UNITED STATES PATENT AND TRADEMARK OFFICE

APPLICATION NO.	FILING DATE	FIRST NAMED INVENTOR	ATTORNEY DOCKET NO.	CONFIRMATION NO.
10/618,689	07/09/2003	Robert L. Doubler	2131.000019	8552
43541	7590	09/29/2006	EXAMINER	
WOOD, HERRON & EVANS (ZIMMER SPINE) 2700 CAREW TOWER 441 VINE STREET CINCINNATI, OH 45202			REESE, DAVID C	
			ART UNIT	PAPER NUMBER
			3677

Office Action Summary	Application No.		Applicant(s)	
	10/618,689		DOUBLER ET AL.	
	Examiner		Art Unit	
	David C. Reese		3677

DETAILED ACTION

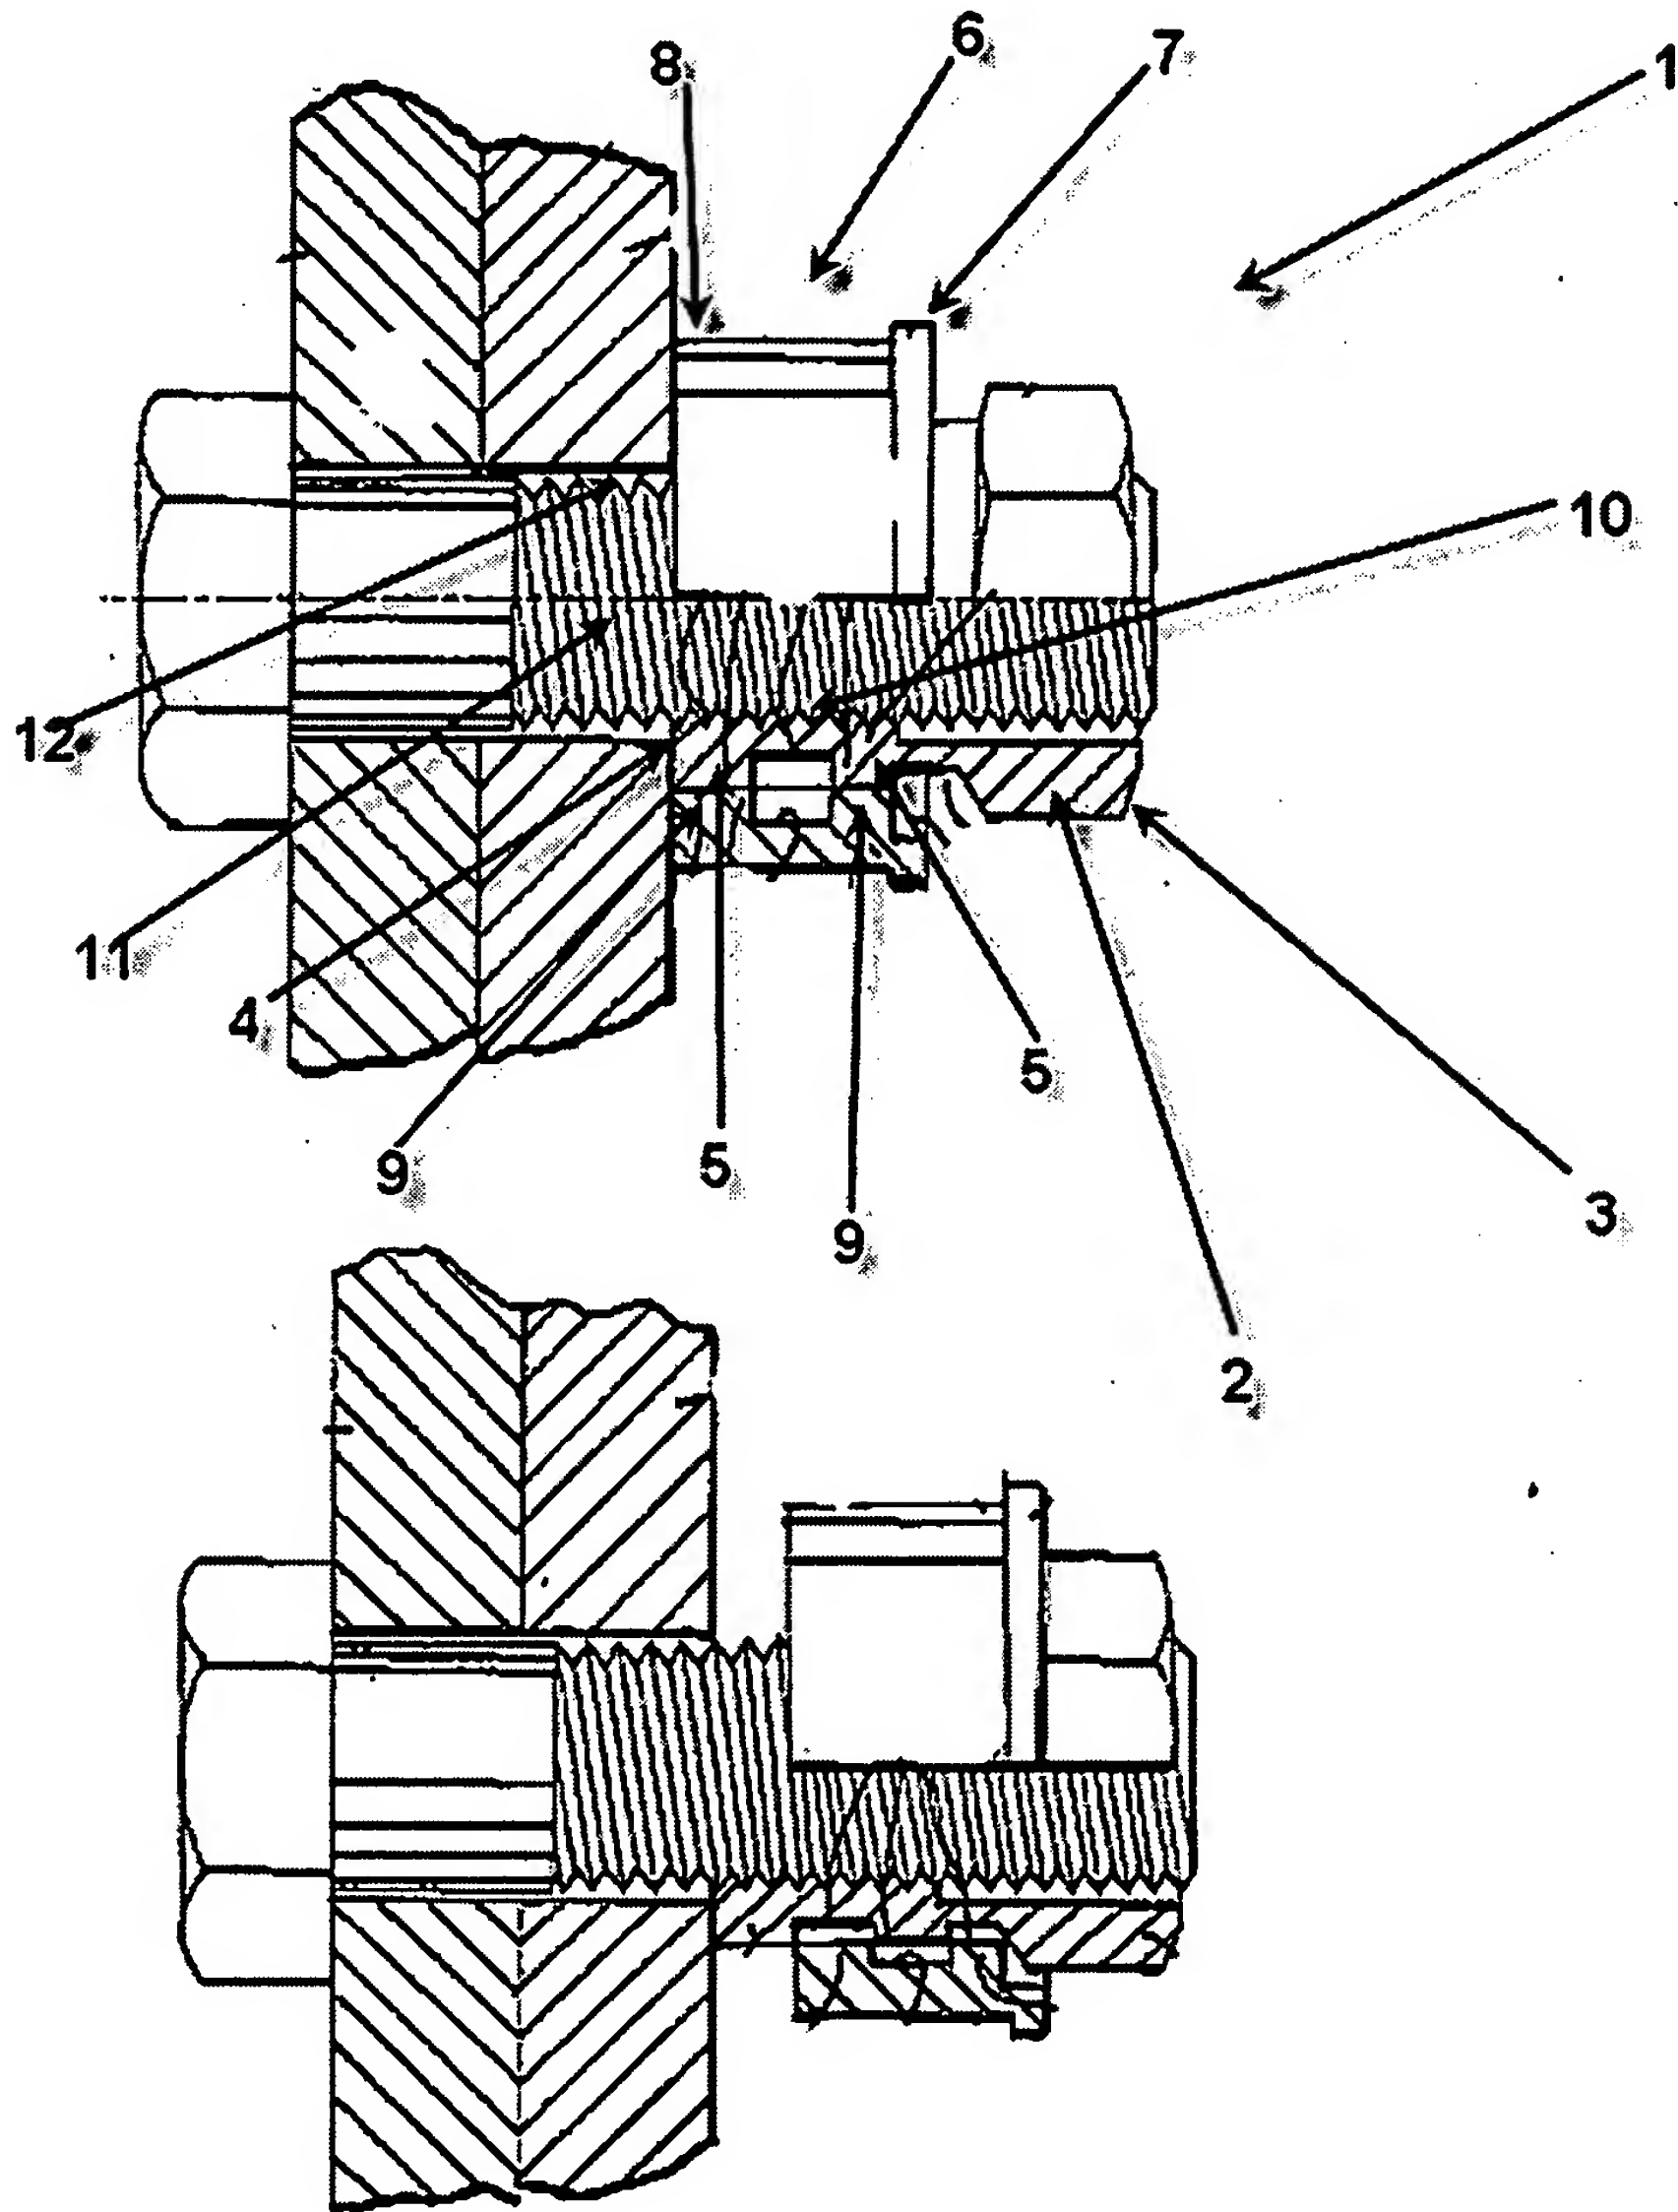
[3] Claims 1-5, 17, and 26 are rejected under 35 U.S.C. 102(b) as clearly anticipated by Batten, US-4,737,059, because the invention was patented or described in a printed publication in this or a foreign country, or in public use or on sale in this country more than one (1) year prior to the application for patent in the United States.

As for Claim 1, Batten discloses a linear fastener system (1) (see figure below) comprising:

a collet member (2) having a base end (4), a top end (3), an inner engaging surface (10), and an outer ribbed surface (5) positioned about a central axis;

a compression ring member (6) having a base end (8), a front end (7), an inner ribbed surface (9), and an outer surface (6) positioned about a central axis;

said inner ribbed surface (9) of said compression ring member (6) being constructed and arranged for coaxial alignment and overlapping engagement with respect to said outer ribbed surface (5) of said collet member (2), said compression ring member (6) non-rotationally linearly traversable with respect to said outer ribbed surface (5) of said collet member (2) between a first release position (bottom figure) and a second engaged position (top figure), wherein said engaged position (top figure) results in said outer ribbed surface (5) of said collet member (2) and said inner ribbed surface (9) of said compression ring (6) compressing said collet member (2) and tensilely loading said compression ring (6) member to engage a shank member (11) having an outer gripping surface (12), and wherein said release position (bottom figure) results in

expansion of said collet member (2) thereby releasing said outer gripping surface (12) of said shank member (11).

Re: Claim 3, wherein said ribbed outer surface (5) of said collet member (2) includes at least one outwardly and circumferentially extending rib (5), each said rib (5) including a first ramp surface to facilitate coaxially aligned linear overlapping movement of said compression ring (6) in relation to said collet member (2) for engagement thereof, and a second ramp surface to facilitate linear removal of said compression ring (6) from said collet member (2).

Re: Claim 17, wherein said outer ribbed surface (5) of said collet member (2) and said inner ribbed surface (9) of said compression ring member (6) are constructed and arranged to maintain an axially aligned interfitting relationship in said release position (bottom figure).

As for Claim 26, Batten discloses a linear fastener system (1) (see figure above) comprising:

a collet member (2) including an outer ribbed surface (5) defining peaks and valleys, and an inner surface (10) adapted to grip a corresponding surface (12) of a shank (11) in a locked condition of said fastener system (top figure);

a compression ring (6) including an inner ribbed surface (9) defining peaks and valleys corresponding to said peaks and valleys (5) of said collet member (2);

the linear fastener system having a locked condition (top surface) wherein said peaks of said collet member (2) and said peaks of said compression ring (6) are in confronting alignment,

and an unlocked condition (bottom figure) wherein said peaks of said collet member (2) are disposed in said valleys of said compression ring (6).

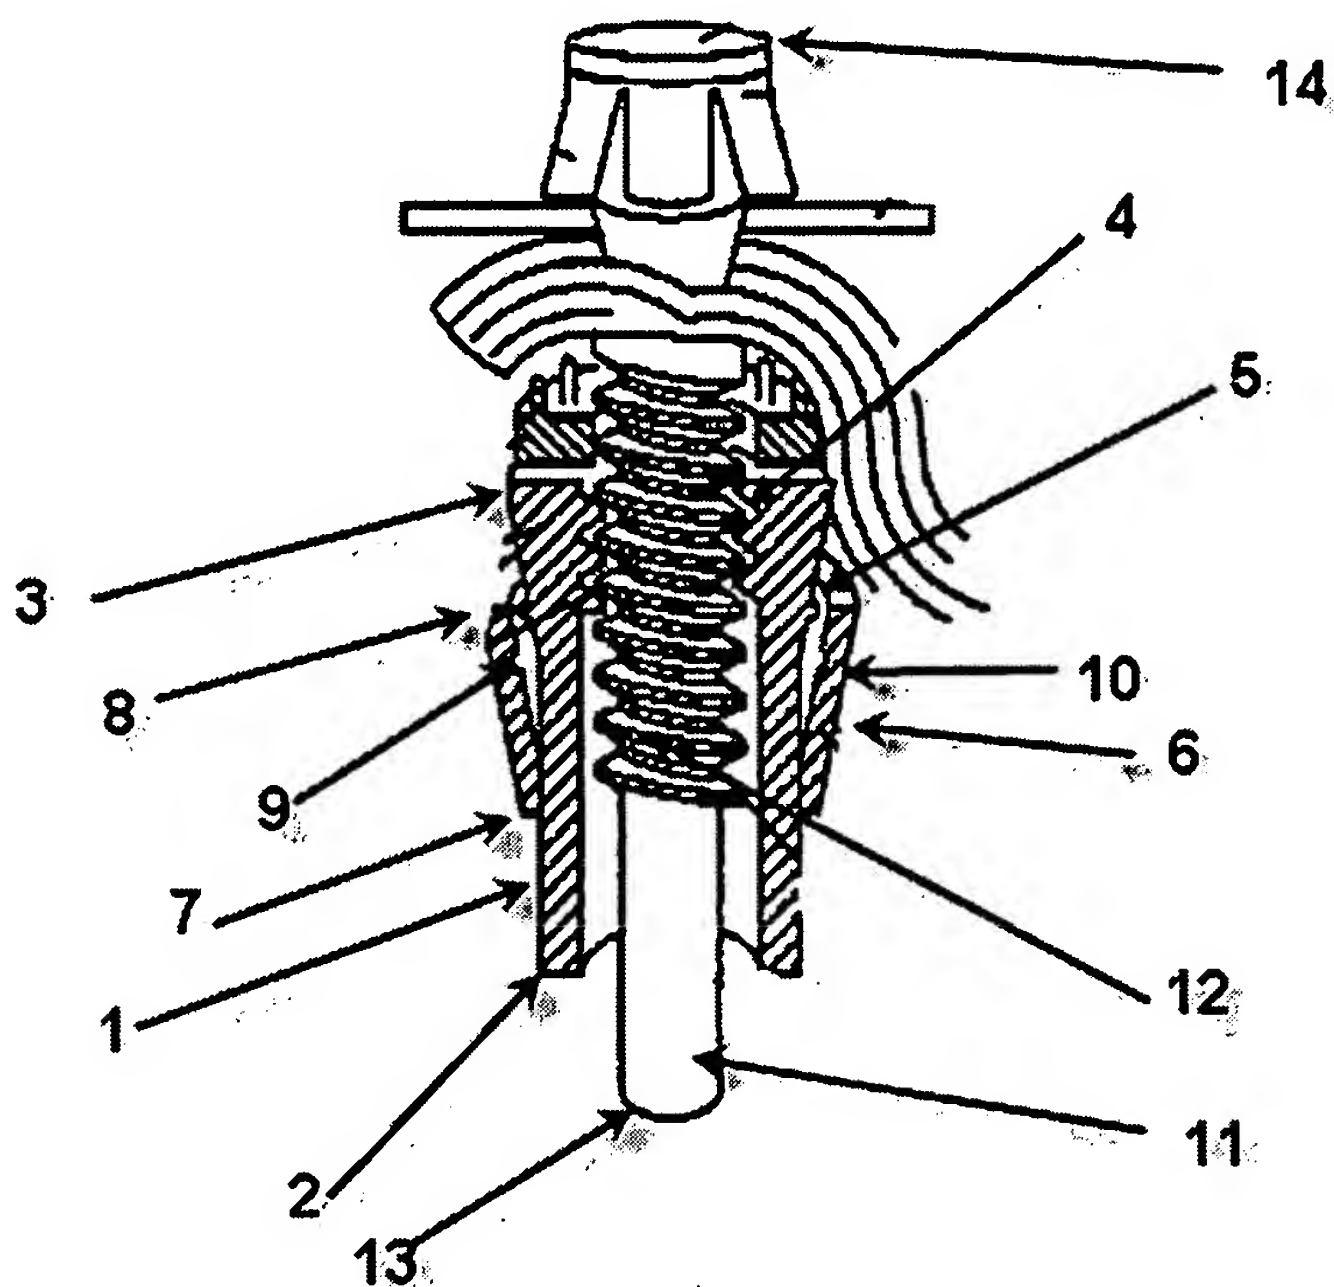
[4] Claims 1-5, 10, 13, and 17 are rejected under 35 U.S.C. 102(b) as clearly anticipated by Freedland et al., US-6,162,234, because the invention was patented or described in a printed publication in this or a foreign country, or in public use or on sale in this country more than one (1) year prior to the application for patent in the United States.

As for Claim 1, Freedland et al. discloses a linear fastener system (see figure below) comprising:

a collet member (1) having a base end (2), a top end (3), an inner engaging surface (4), and an outer ribbed surface (5) positioned about a central axis;

a compression ring member (6) having a base end (7), a front end (8), an inner ribbed surface (9), and an outer surface (10) positioned about a central axis;

said inner ribbed surface (9) of said compression ring member (6) being constructed and arranged for coaxial alignment and overlapping engagement with respect to said outer ribbed surface (5) of said collet member (1), said compression ring member (6) non-rotationally linearly traversable with respect to said outer ribbed surface (5) of said collet member (1) between a first release position and a second engaged position, wherein said engaged position results in said outer ribbed surface (5) of said collet member (1) and said inner ribbed surface (9) of said compression ring (6) compressing said collet member (1) and tensilely loading said compression

ring (6) member to engage a shank member (11) having an outer gripping surface (12), and wherein said release position results in expansion of said collet member (1) thereby releasing said outer gripping surface (12) of said shank member (11).

Re: Claim 3, wherein said ribbed outer surface (5) of said collet member (1) includes at least one outwardly and circumferentially extending rib (5), each said rib including a first ramp surface to facilitate coaxially aligned linear overlapping movement of said compression ring (6) in relation to said collet member (1) for engagement thereof, and a second ramp surface to facilitate linear removal of said compression ring (6) from said collet member (1).

Re: Claim 10, wherein said first end (14) of said shank member (11) includes a tensioning means (111E1 in Fig. 43), said tensioning means (111E1 in Fig. 43) being constructed and arranged to allow said shank member (11) to be tensilely loaded (via 6) prior to linear traversal of said compression ring member (6) into said engagement position with respect to said collet member (1).

Re: Claim 17, wherein said outer ribbed surface (5) of said collet member (1) and said inner ribbed surface (9) of said compression ring member (6) are constructed and arranged to maintain an axially aligned interfitting relationship in said release position (with compression member (6) near the bottom of said collet member, (1)).

[10] Applicant's arguments filed 7/21/2006 regarding rejections under Freedland et al. under 35 U.S.C. 102 have been fully considered but they are not persuasive. Applicant primarily refutes the application of Freedland et al. in the instant set of claims stating that Freedland et al. does not disclose "an inner ribbed surface." The examiner disagrees. The examiner maintains that Freedland et al. does indeed disclose a compression ring member (6) having a base end (7), a front end (8), and an inner ribbed surface (9).
